# Authorized Field Change

AFC G-06909-R1

**Subject:** Cab Entry/Egress Improvement and Air Line/Fitting Protection for Certain International® 8600 Models Built Between April 10, 2006 and June 5, 2006 with Feature Codes 16ZGM and 508046

**Figure 1 Battery Box Steps**

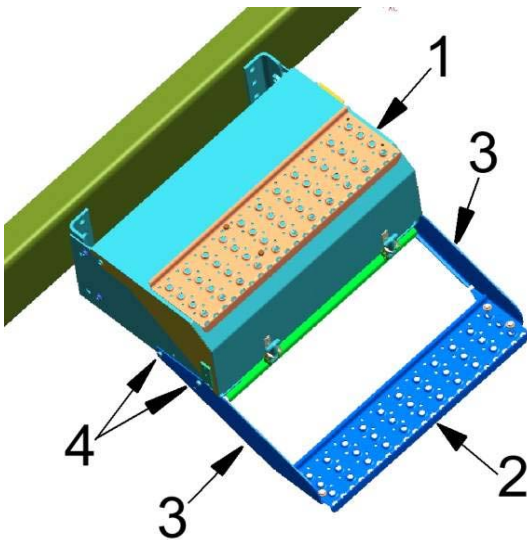
1. Remove the current battery box lid step plate fasteners and step plate (Figure 1, Item 1). The step plate will be reused later in this service procedure.
2. Remove the fasteners and lower step plate (Figure 1, Item 2). The step plate and fasteners will be reused later in this service procedure.

3. Open the battery box lid and disconnect the negative battery cable to access the right and left hand step bracket fasteners. Remove the step bracket fasteners (Figure 1, Item 4) on both sides and brackets (Figure 1, Item 3). Save the fasteners for reuse in Step 4.

**Figure 2 New Step Plate Arrangement**

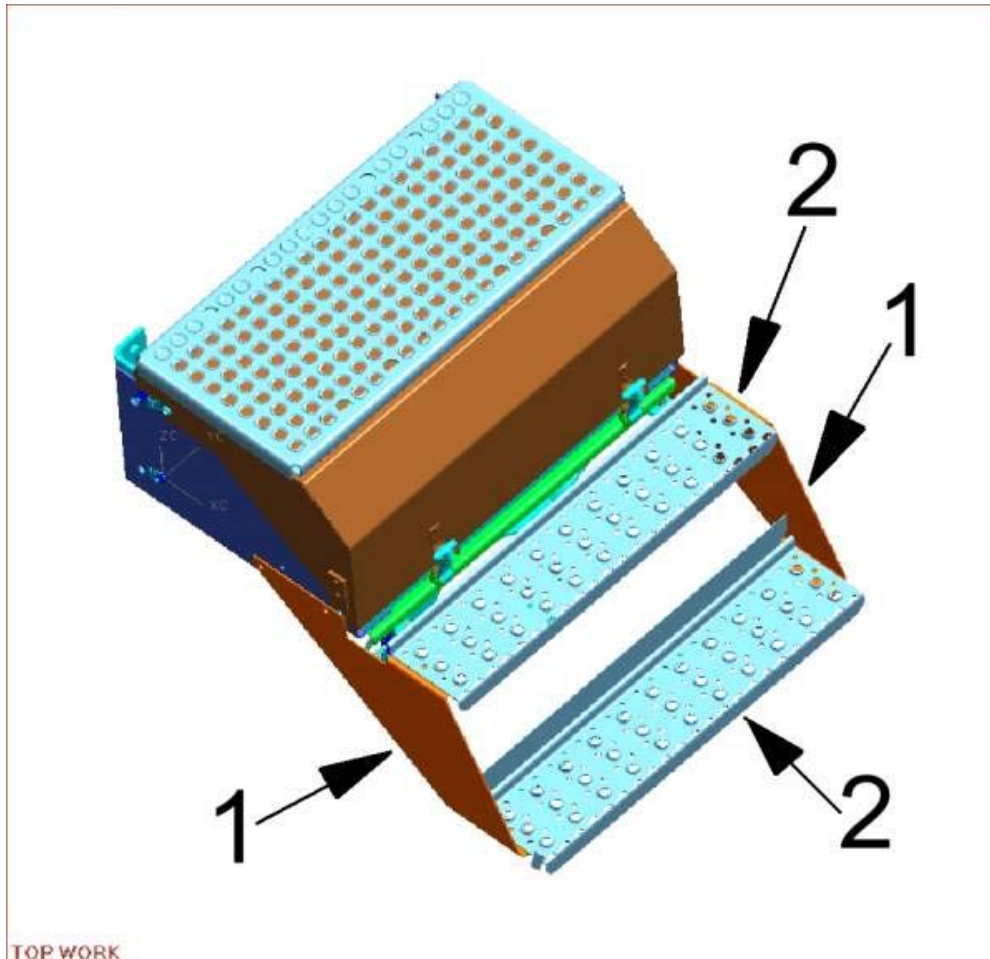
4. Install the new right (3808896C1) and left (3808895C1) side step brackets (Figure 2, Item 1) with the fasteners removed in Step 3. Tighten the fasteners to 12.6 to 15.5 Nm.
5. Re-install the step plates (Figure 2, Item 2) removed in Steps 1 and 2. Reuse the fasteners from Step 2 for one of the steps and use bolt, part number 3555605C1, and nut, 3541323C1, for the other step. Tighten the step fasteners to 19.6 to 24.0 Nm.

**Figure 3 Battery Box Lid**

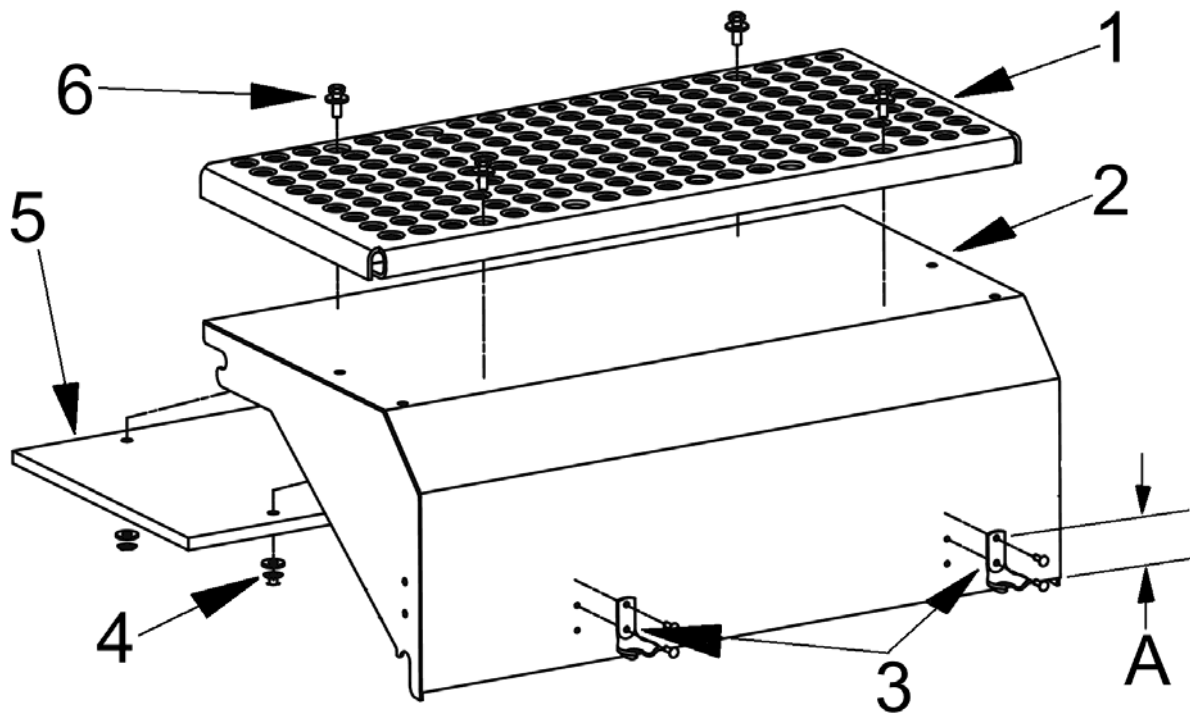
6. Open the battery box lid. Position the plywood insulator inside the battery box lid, as shown in Figure 3, Item 5. Center the plywood in the lid and use the 4 holes as a template for drilling the lid. Drill 4 holes through the lid.
7. Hold the plywood insulator in position and place the deck plate (Figure 3, Item 1) on the top surface of the battery box lid. Install a bolt and washer (Figure 3, Item 6) through the deck plate, through the battery box lid and through the plywood insulator. Install a washer and nut (Figure 3, Item 4) hand tight. Repeat for the remaining three holes. Make sure the deck plate is aligned properly on the battery box lid and tighten the fasteners to 12.6 to 15.5 Nm.

- 8. Verify the battery box hold down (Figure 3, Item 3) is in the proper position:

- A. Measure from the bottom edge of the battery box lid to the hold down top rivet hole (Figure 3, Item A). If the dimension is 91 mm (23/64 inch) go no further. Go to the next Step.
  - B. If the dimension is not correct, adjust as needed. Note: new holes may be required to achieve 91 mm.
9. Reconnect the negative cable to the battery.
